H11075

DESCRIPTIVE REPORT

Descriptive Report to Accompany Hydrographic Survey H11075

Project OPR-P359-RA-01
Approaches to Seward, Alaska
Scale 1:20,000
August - September 2001
NOAA Ship RAINIER
Chief of Party: Captain James C. Gardner, NOAA

Figure 1. H11075 Survey Limits

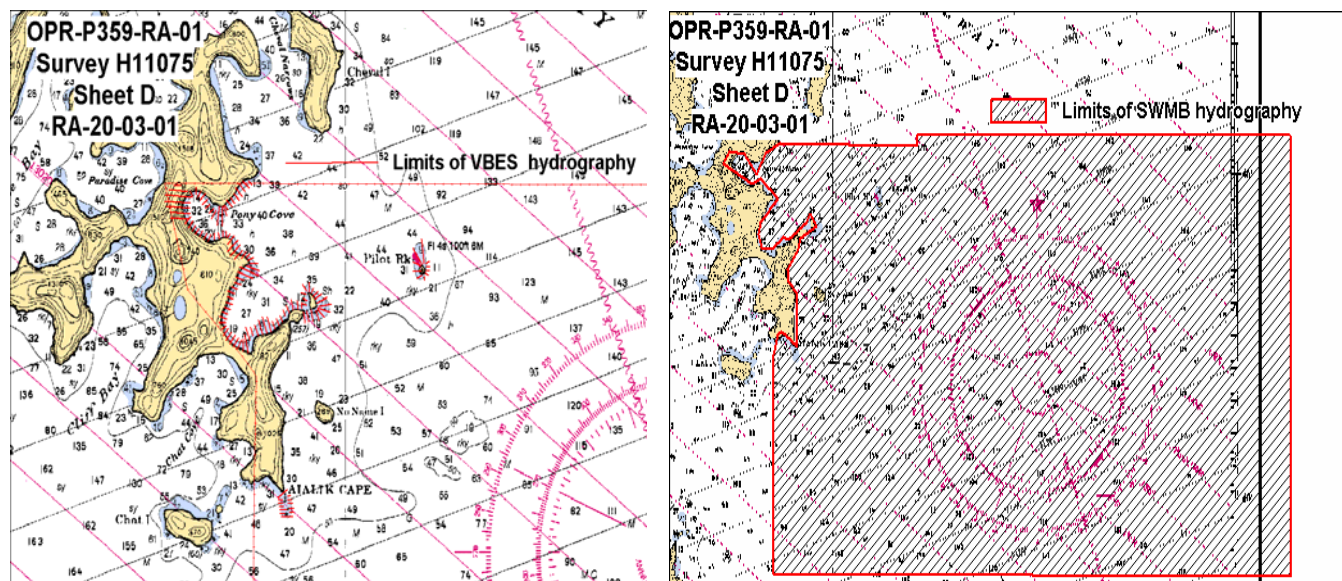
The survey covers the area east of Aialik Cape. The survey's northern limit is latitude 59°45'21"N¹ and the southern limit is latitude 59°38'47"N². The survey's western limit is longitude 149°32'11"W³ and the eastern limit is longitude 149°12'24"W⁴.

- ¹ PHB Revision--Strikethrough ~~59°45'21"N~~ and replace with 59°45'43"N.
- ² PHB Revision--Strikethrough ~~59°38'47"N~~ and replace with 59°38'31"N.
- ³ PHB Revision--Strikethrough ~~149°32'11"W~~ and replace with 149°34'06"W.

- ⁴ PHB Revision--Strikethrough ~~149°12'24"W~~ and replace with 149°11'48"W.
- ⁵ Filed with Project Records.
- ⁶ Concur with hydrographer's statements.
- ⁷ Filed with the hydrographic data.

Figure 2. H11075 Junction Surveys

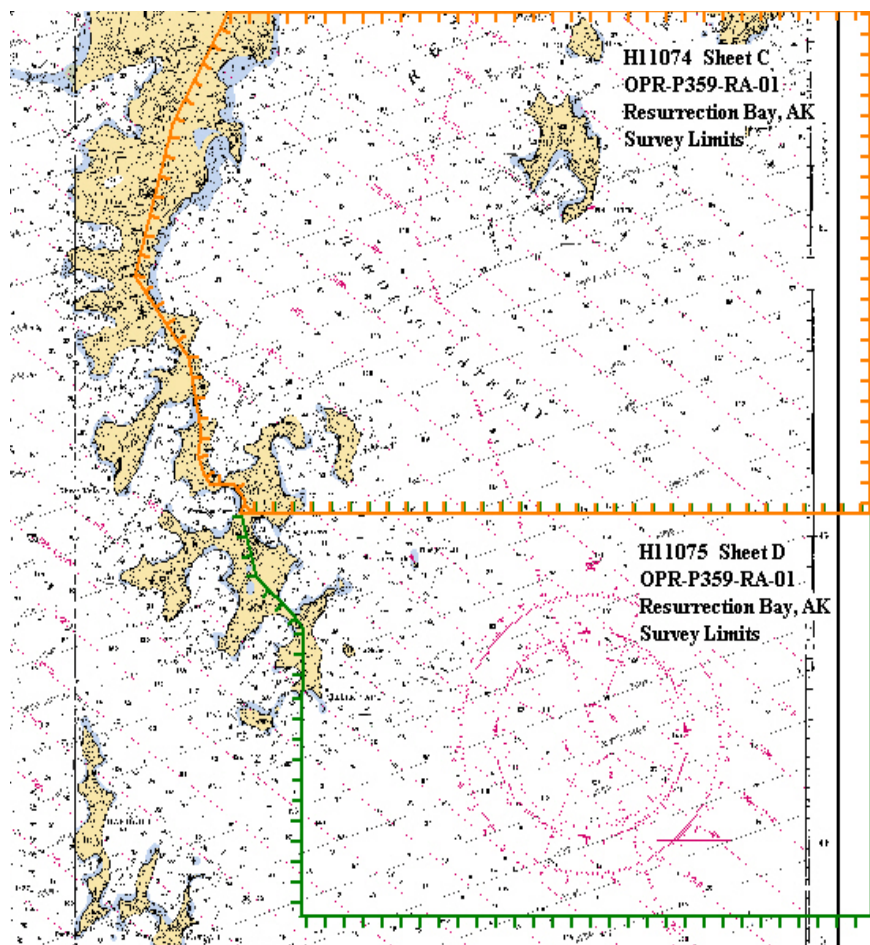
The following survey junctions with H11075. ⁹

Registry #	Scale	Date	Junction side
H11074	1:20,000	2001	North

At the time of this report, processing of survey H11074 was not complete. Comparisons of the junction with this survey will be discussed in the Descriptive Report for H11074. ¹⁰

Final comparisons will be made at the Pacific Hydrographic Branch (PHB) after the application of smooth tides. ¹¹

- ⁸ Concur with hydrographer's statements.
- ⁹ Junction was also made with H11010 during office processing (1:20,000, 2000, west). Junctions were made during office processing. There was good agreement and "Joins" notes have been added to the smooth sheet.

- ¹⁰ Concur. See endnote 11.
- ¹¹ Concur with clarification. Junction comparisons were made with H-11074 and H-11010 during office processing. Soundings and depth curves are in good agreement and "Joins" notes have been added to the smooth sheet.
